POTENTIALLY UNQUALIFIED COMPONENT IN CERTAIN ALLEN BRADLEY TIMING RELAYS

"Report of potential 10 CFR Part 21, Allen Bradley Timing Relay Model 700RTC

UPDATE - Report of potential 10CFR Part 21, Allen Bradley Timing
Relay Model 700RTC
Report No: P21-04302015, Rev. 4

Part 21 Report No: P21-04302015, Rev. 4

Figure 2 - New design circuit board and CPLD that replaced the original component.

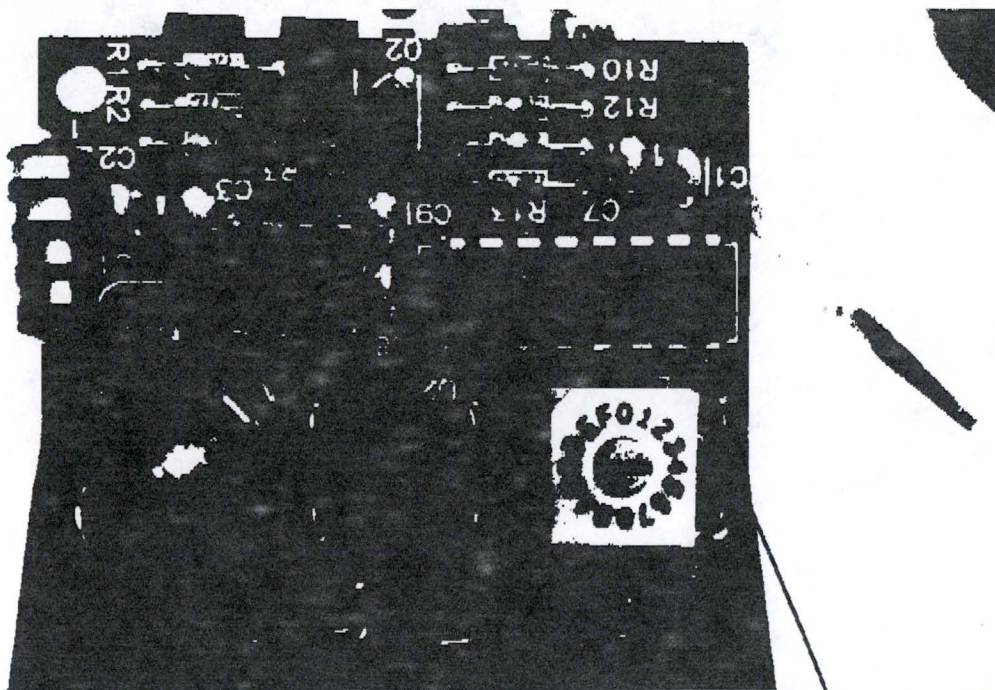
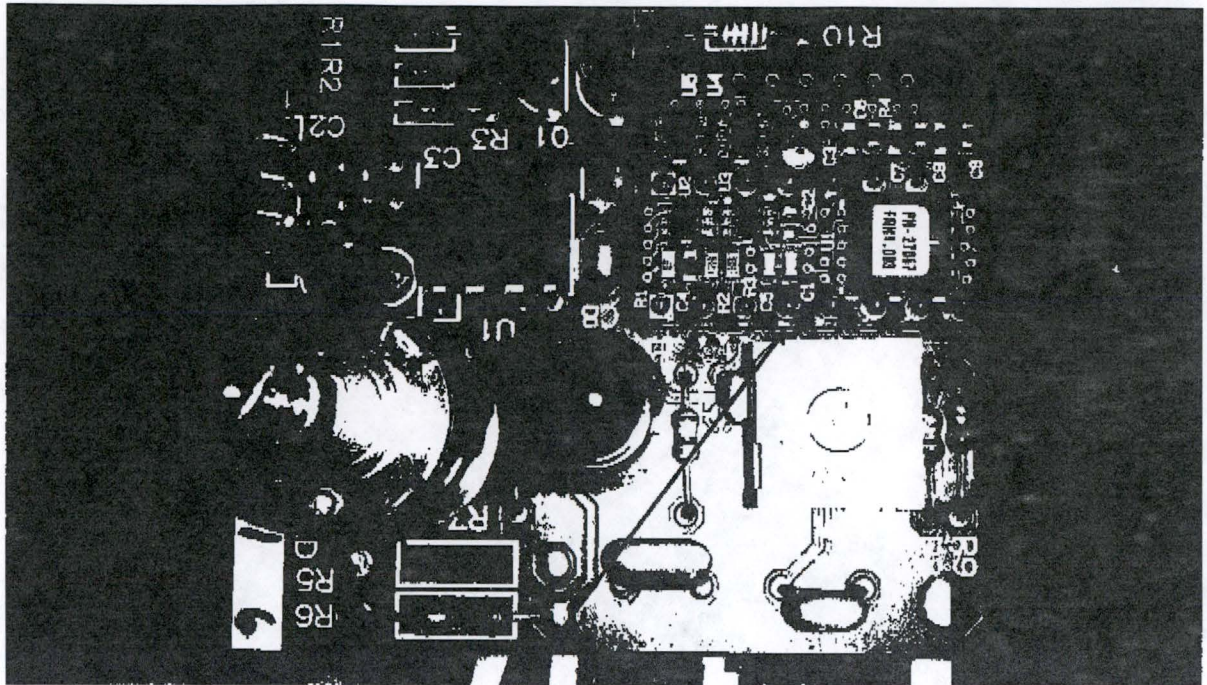
In October 2008, Allen Bradley made a design change without changing the part number of the commercial relay or providing any documented evidence of a design change. The manufacturer specification data sheets maintain the classification that the relays are "solid state", which would imply that there are no digital devices installed in the relay. However, after inspection of the internals of the timing relay (Figure 2), it has been identified that the unit does contain a CPLD which meets the definition of a digital device under the guidance of NEI 01-01. See Figures 1 and 2 below:

Figure 1- Original qualified design (prior to October 2008).
Relays supplied prior to October 2008 are not affected by this issue.

The results were satisfactory with exception of the following condition: During Conducted Susceptibility CS114 onto the power lines, with the timing circuit in operation, the **Normally Open Timing contact** exhibited chatter (changed state) in the range of 3.3 MHz to 24.0 MHz. **Supplemental testing was conducted to confirm the Timing contact was susceptible to the condition.** The unit requires a ferrite to be installed onto the input power lines of the relay with 3 turns through the ferrite core. In this modified configuration, the relay was not susceptible to Conducted Susceptibility and successfully passed the required test per CS114.
